**Ladder Diagrams for Error  
Recovery For FCP -2 Rev 04  
Out-Of-Order Delivery- Annex D**

**Carl Zeitler**

**Compaq Computer Corporation**

**T10/00-137**

# D.3 Class 2 FCP\_XFER\_RDY Lost

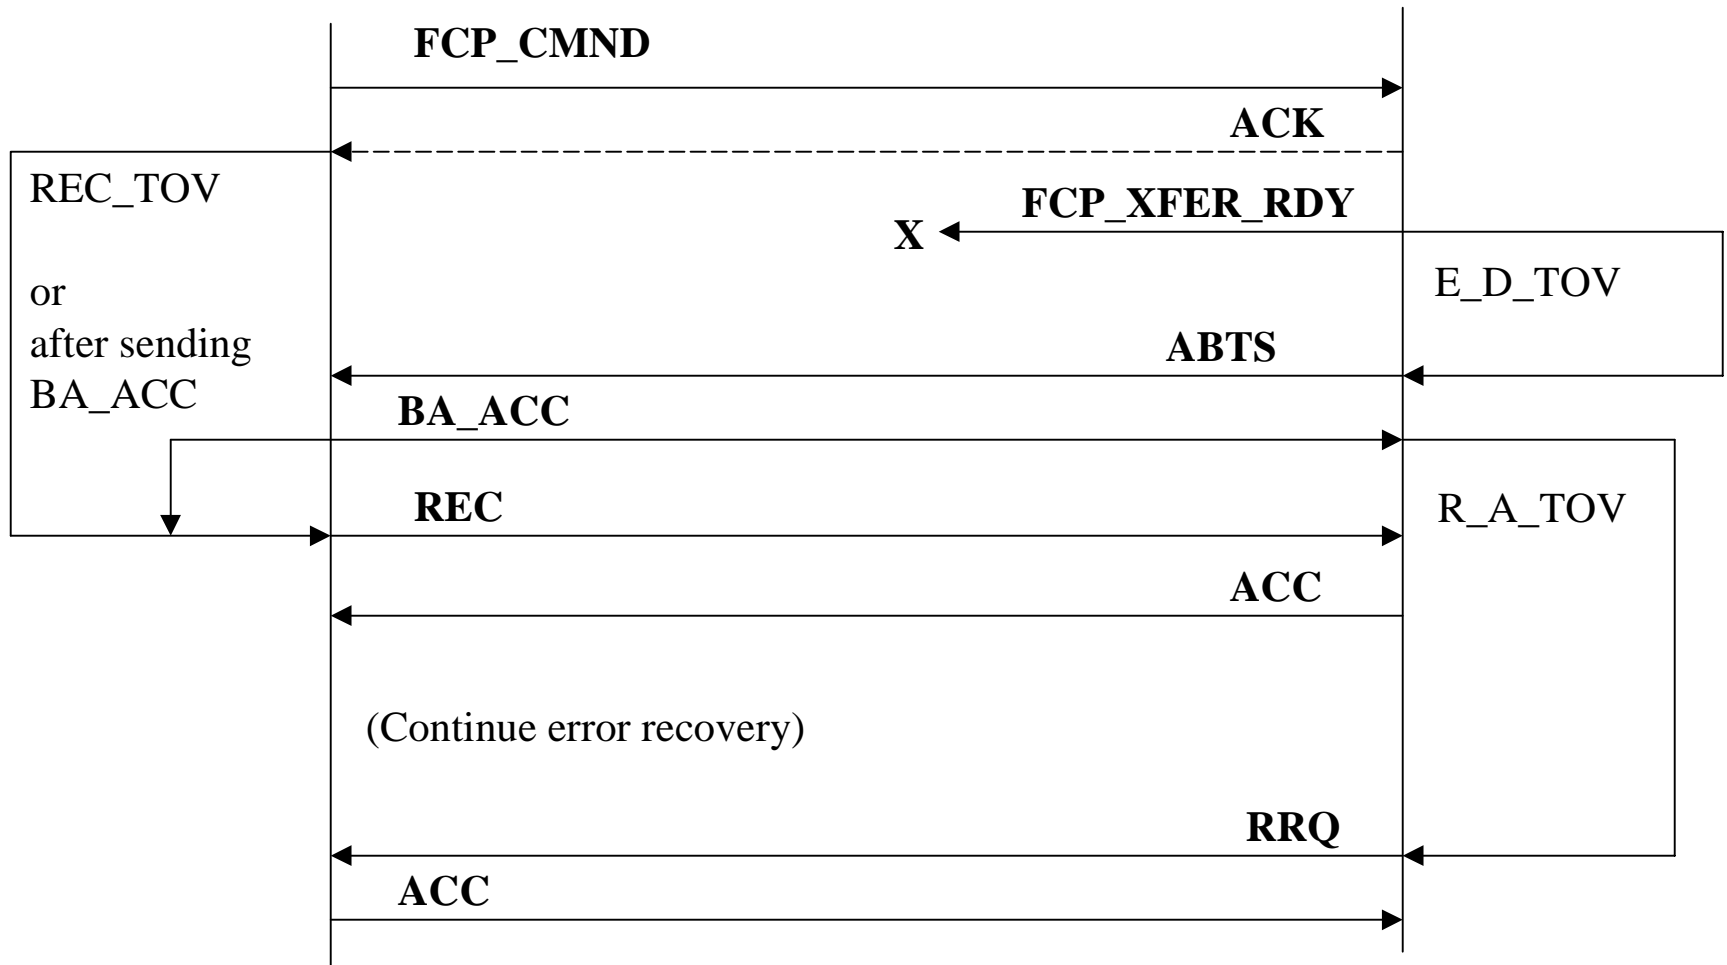
## Error Recovery Addition

A new SEQ\_ID must be used in the retransmission of FCP\_XFER\_RDY. For Class 2, the SEQ\_CNT value used must be one greater than the value used in the ABTS frame.

# D.5 Class 2 FCP\_RESP Lost, No FCP\_CONF Req.

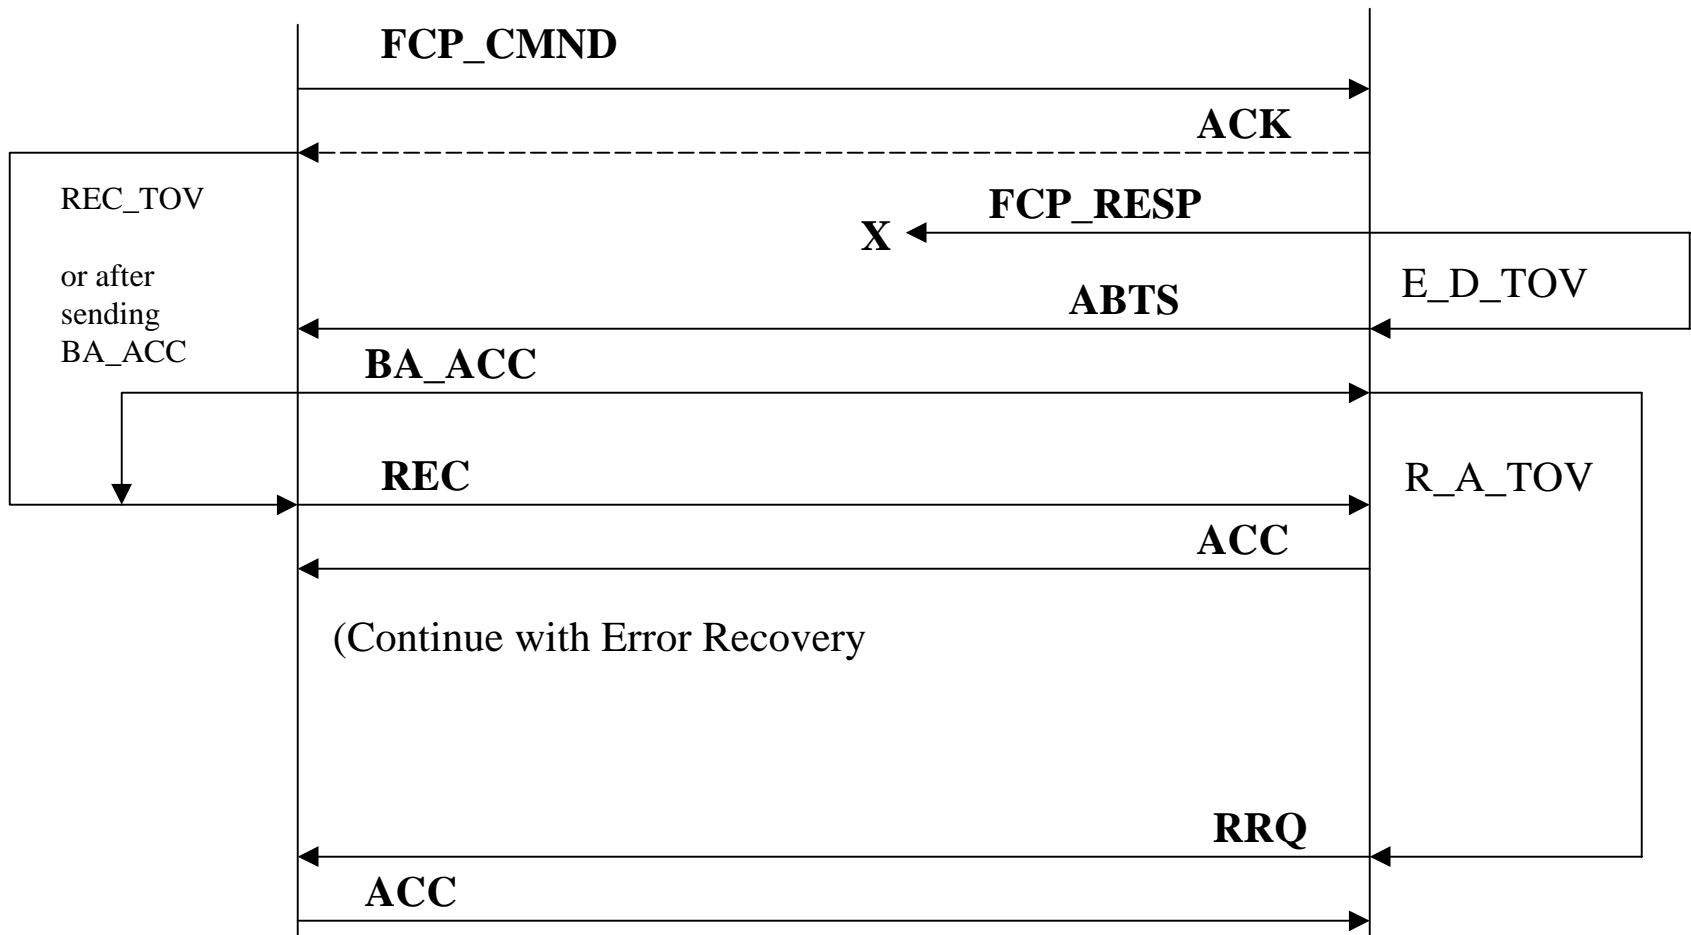
## Error Recovery Addition

A new SEQ\_ID must be used in the retransmission of FCP\_RESP. For Class 2, the SEQ\_CNT value used must be one greater than the value used in the ABTS frame.

# D.7 Class 2 Lost Write Data, Last Frame of Seq.

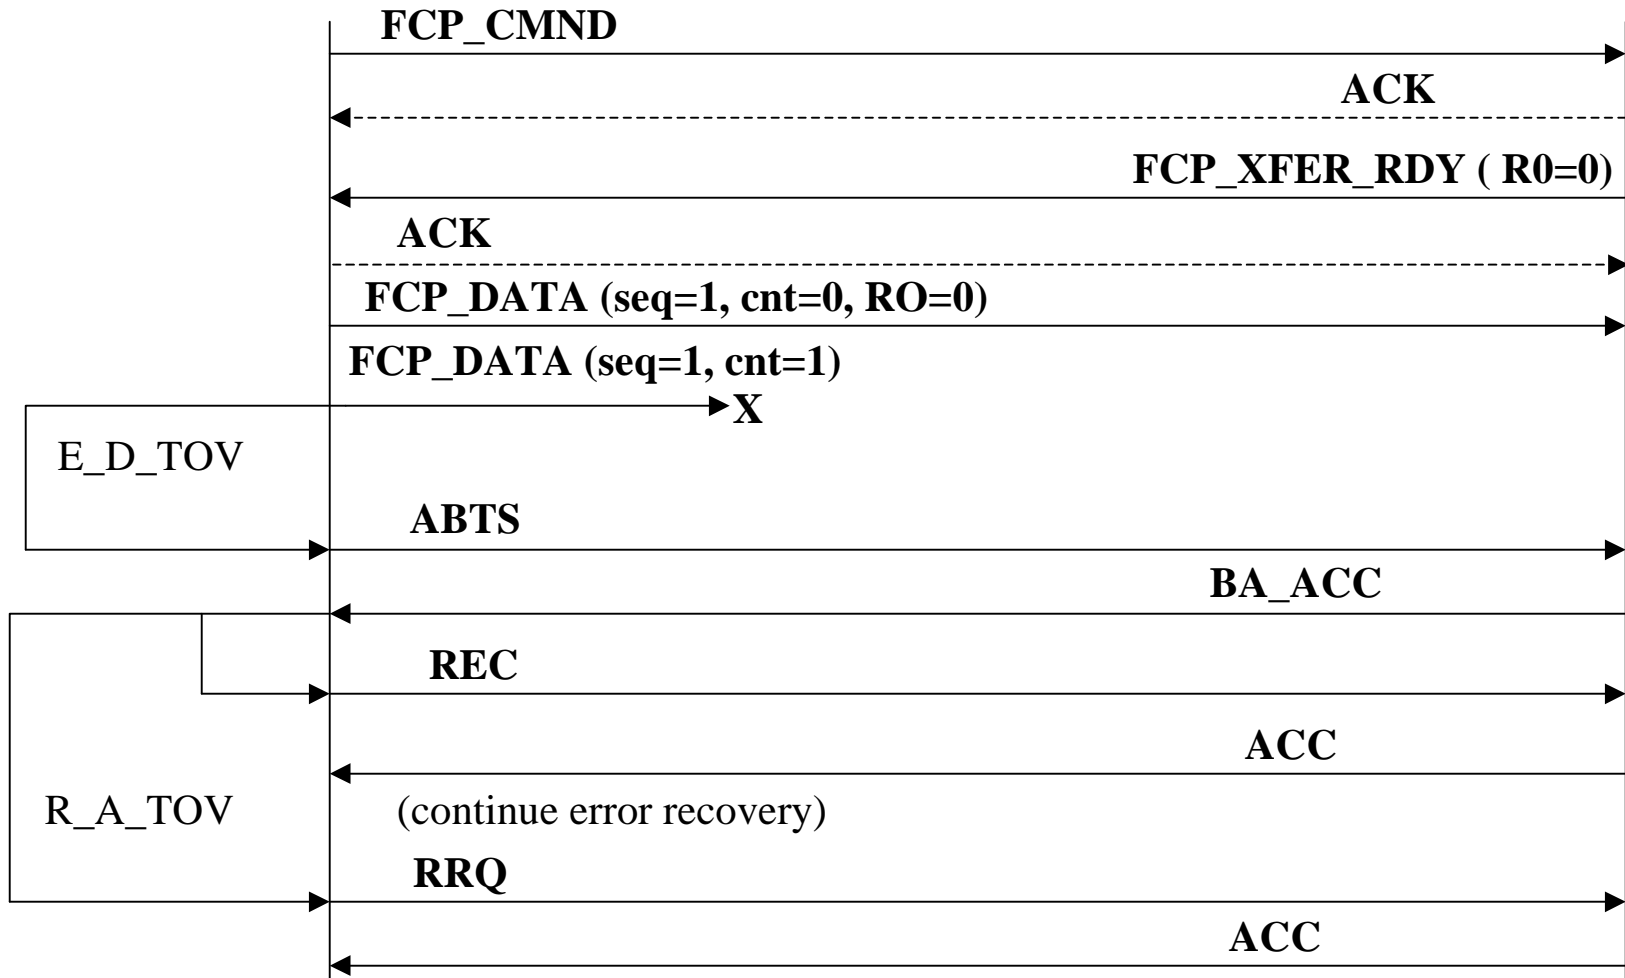
## Error Recovery Addition

New Sequence Ids shall be used for the retransmission of FCP\_XFER\_RDY and FCP\_DATA. For Class 2, the starting Sequence count value used with the retransmission of FCP\_DATA frames shall be one greater than the value used in ABTS.

# D.8 Class 2 Lost Write Data, Not Last Frame of Seq.

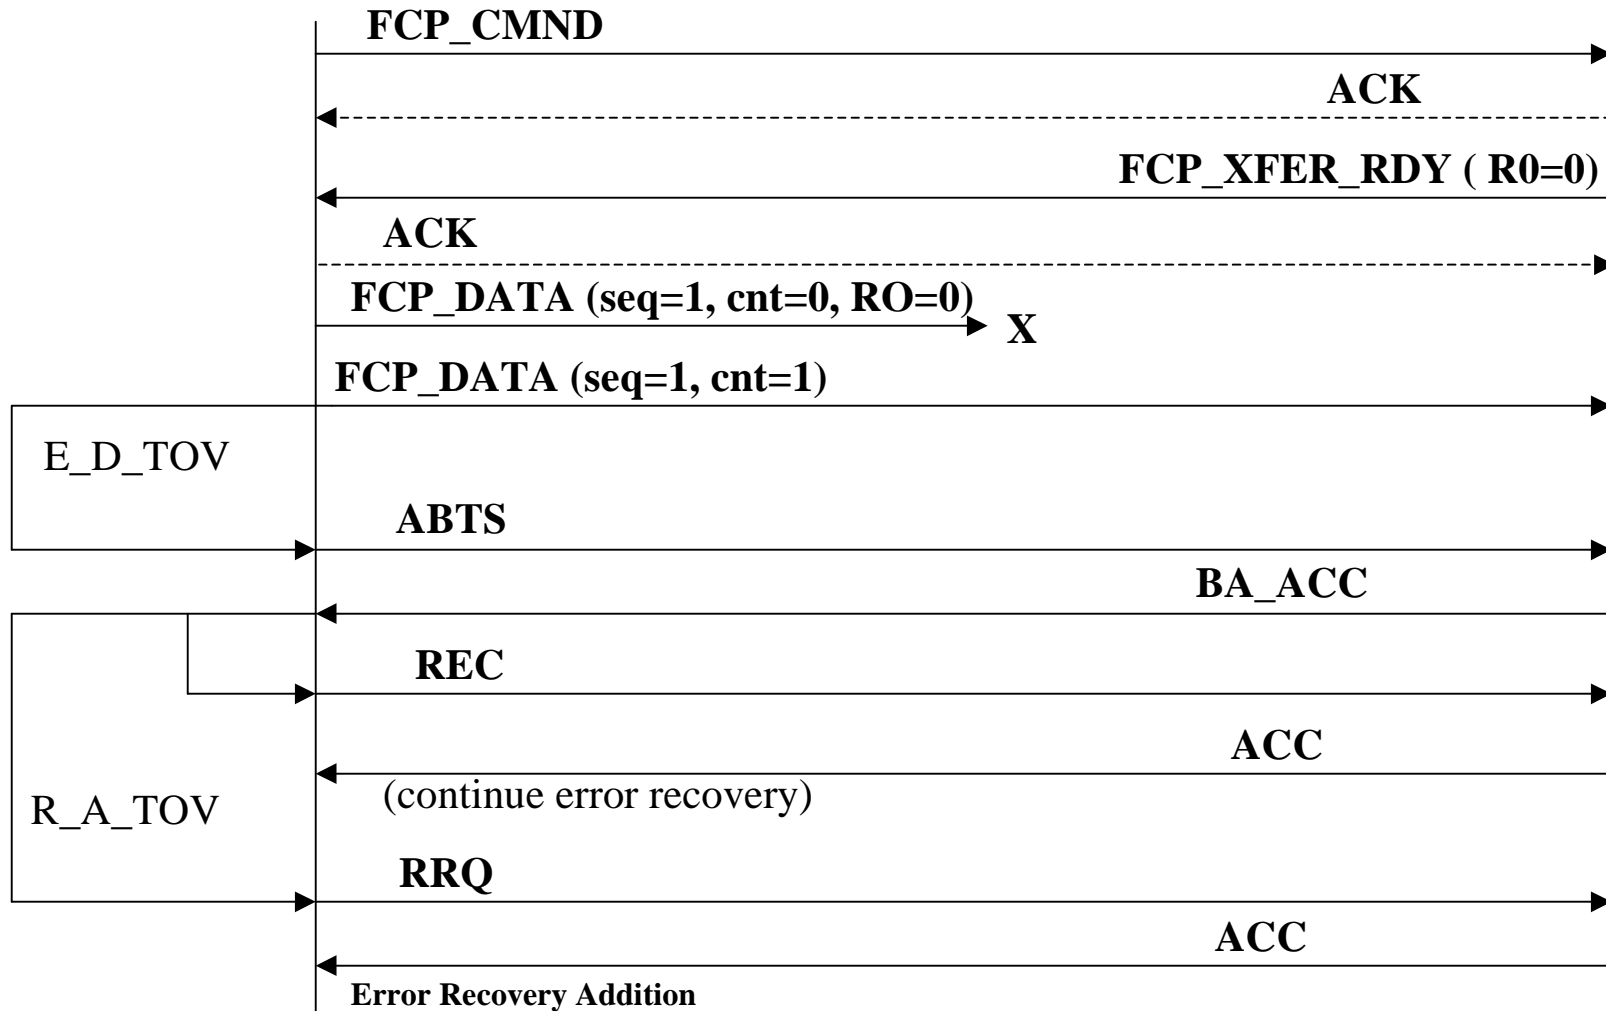
## Error Recovery Addition

New Sequence IDs shall be used for retransmission of FCP\_XFER\_RDY and FCP\_DATA.

For Class 2, the Sequence count value used with the retransmission of FCP\_DATA shall be one greater than the value used in ABTS.

# D.9 Class 2 Lost Read Data, Last Frame of Seq.

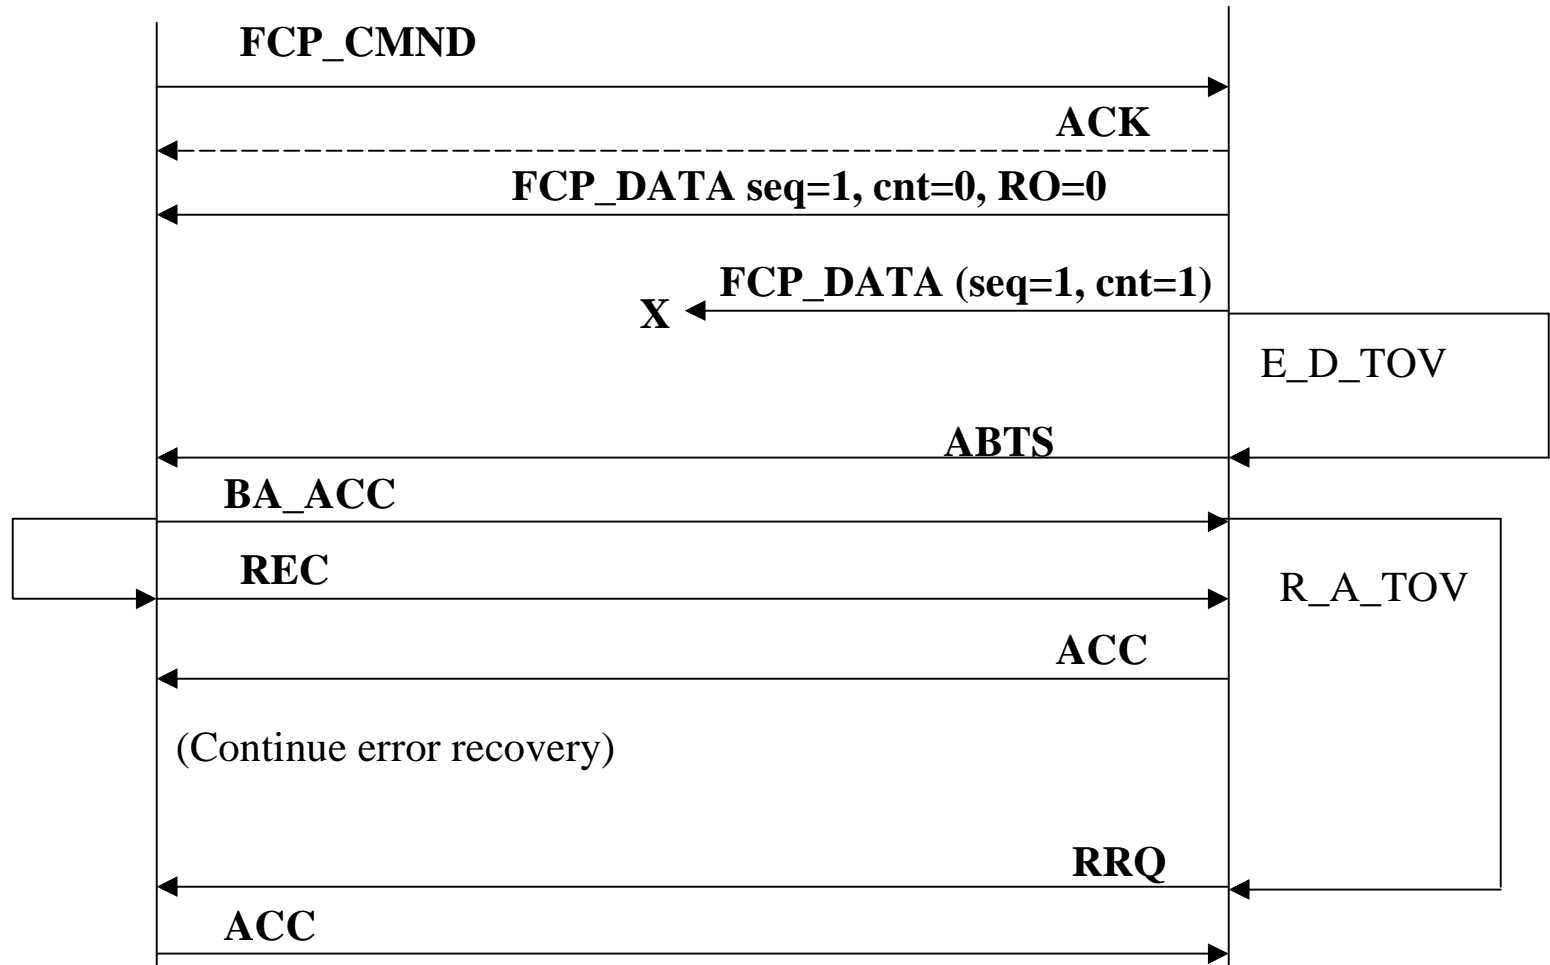
## Error Recovery Addition

New Sequence IDs shall be used for retransmission of FCP\_XFER\_RDY and FCP\_DATA.

For Class 2, the Sequence count value used with the retransmission of FCP\_DATA shall be one greater than the value used in ABTS.

# D.10 Class 2 Lost Read Data, Not Last Frame of Seq

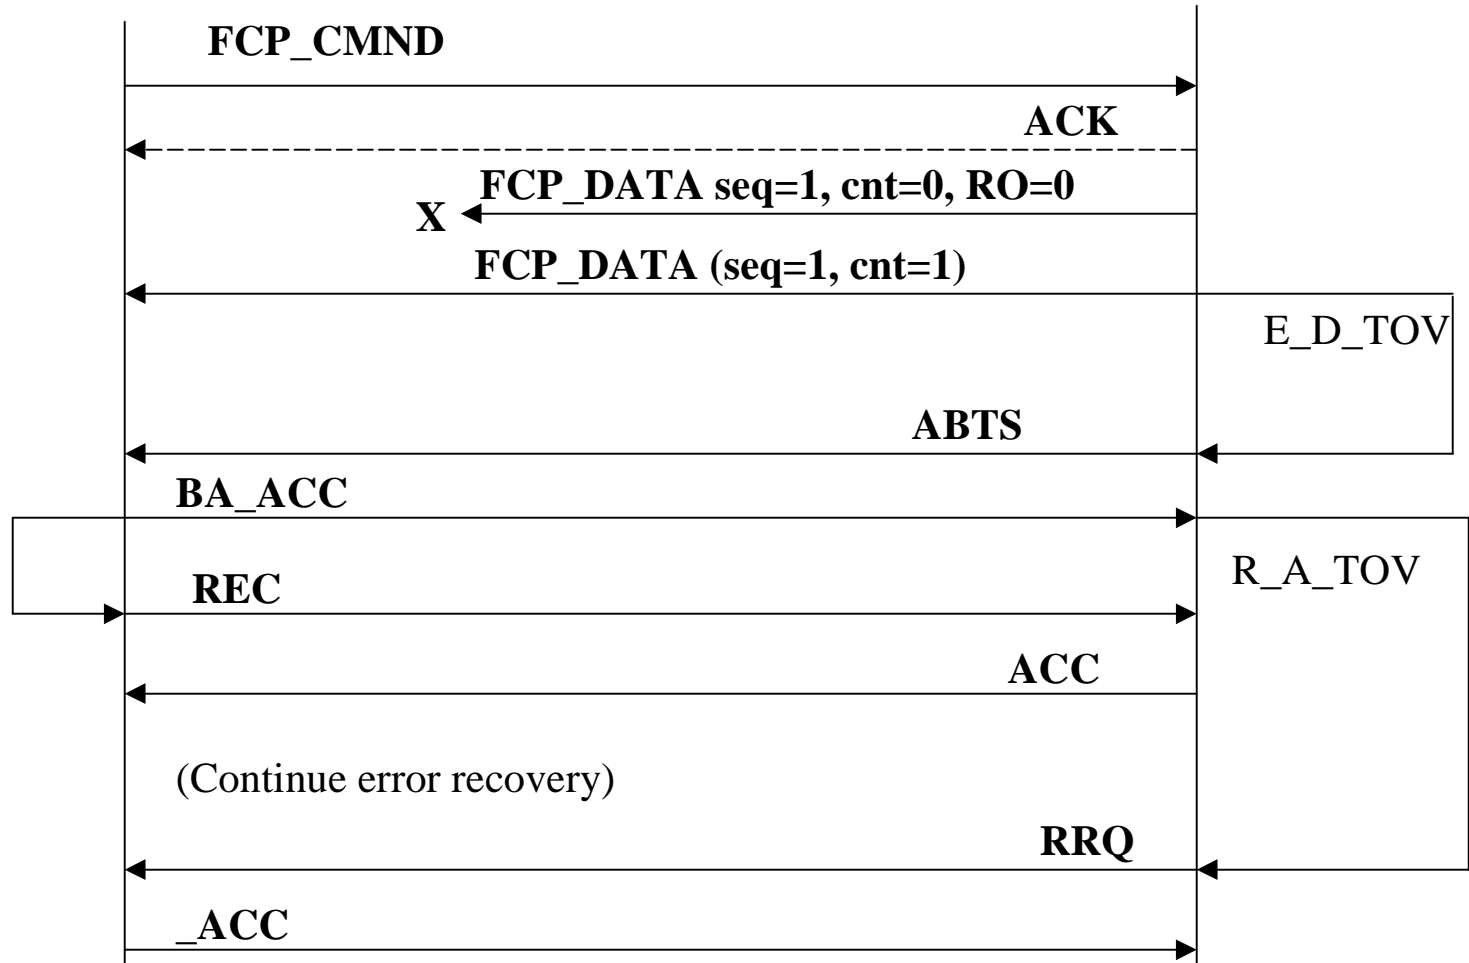
## Error Recovery Addition

New Sequence IDs shall be used for retransmission of FCP\_XFER\_RDY and FCP\_DATA.

For Class 2, the Sequence count value used with the retransmission of FCP\_DATA shall be one greater than the value used in ABTS.

# D.?? Class 2 FCP\_CONF Lost

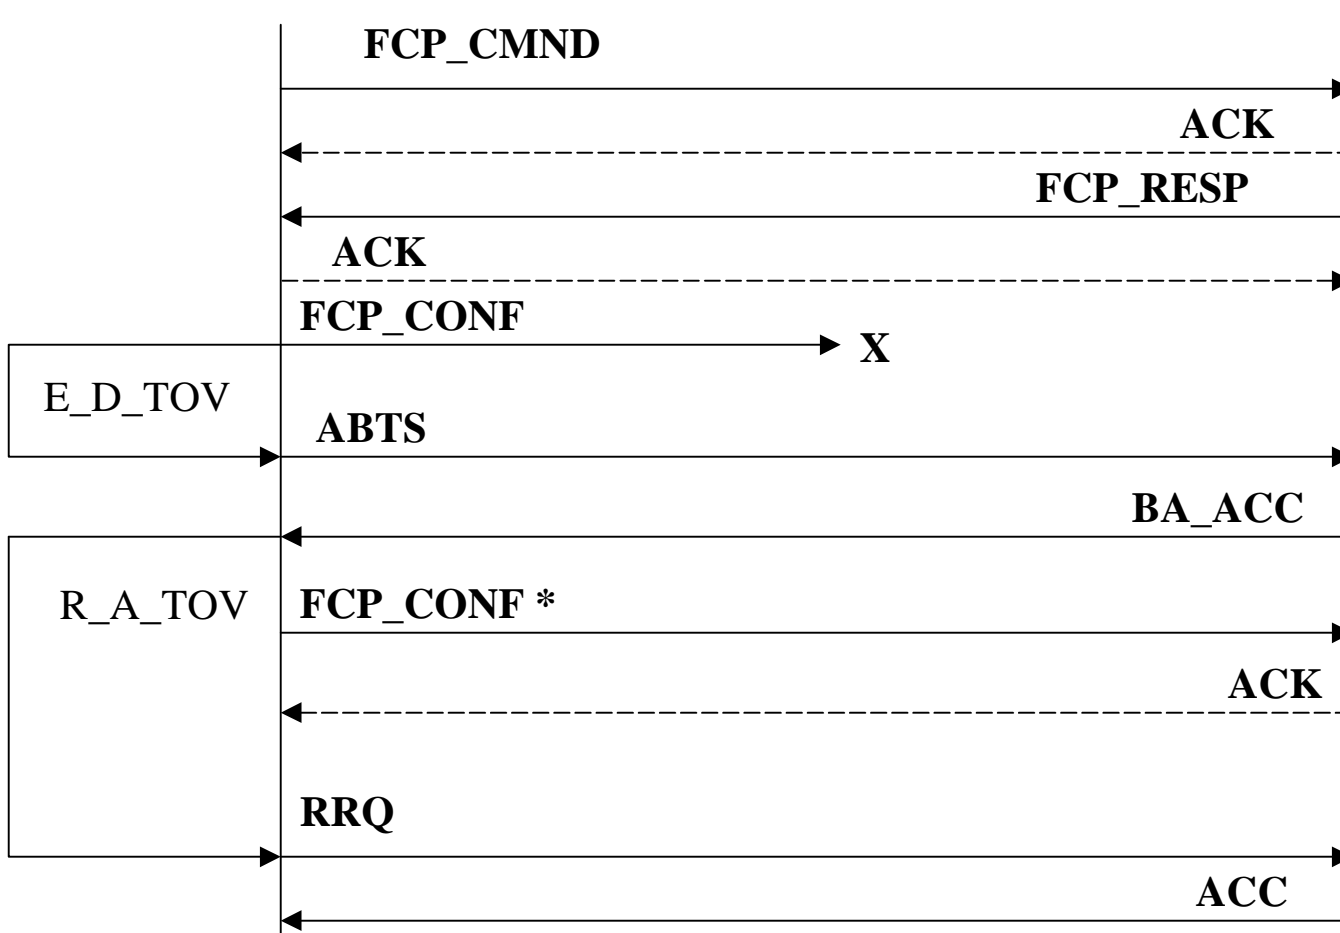
\* Second FCP\_CONF must be sent with a different SEQ\_ID. The SEQ\_CNT value used in the retransmission of FCP\_CONF must be one greater than the value used in the ABTS frame.
